### **Submission to the WestConnex New M5 Environmental Impact Statement**

# WestConnex New M5 Environmental Impact Statement

City of Sydney submission to the Department of Planning and  
Environment

Figure 2 - New M5 EIS - Traffic and Transport study area

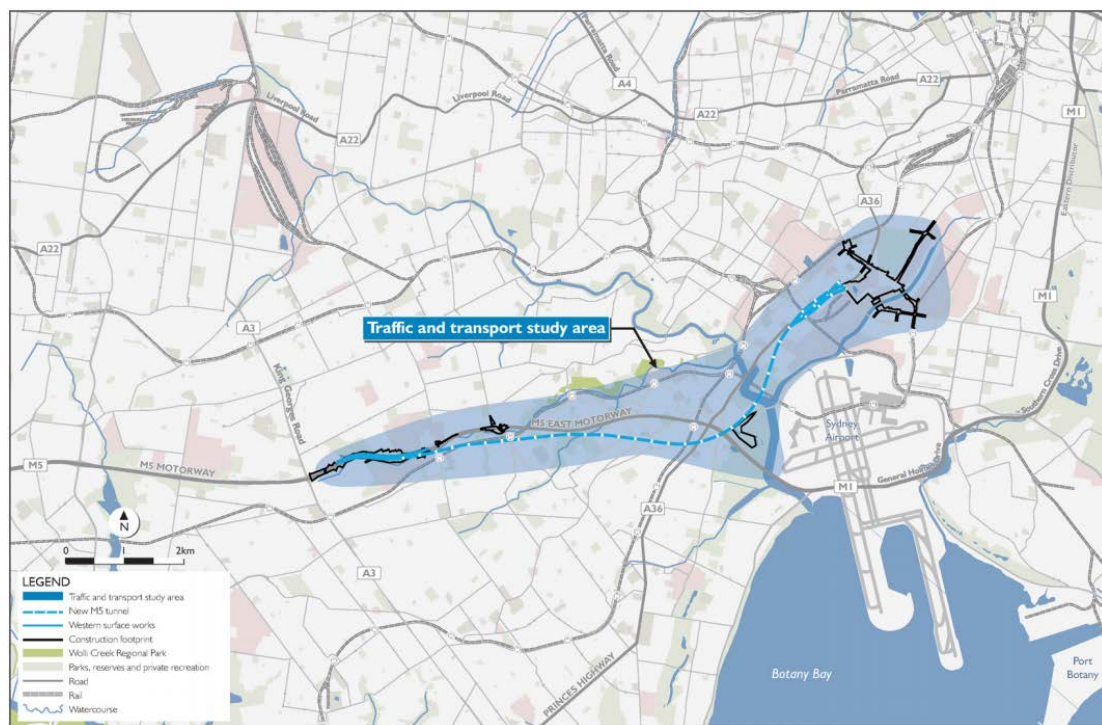
The select links were intended to inform the City's understanding of the project's impact on areas such as Erskineville, Alexandria, Green Square and the Ashmore precinct, which were omitted from the EIS. TTM Consulting undertook a robust analysis of the data provided and the following key points can be made:
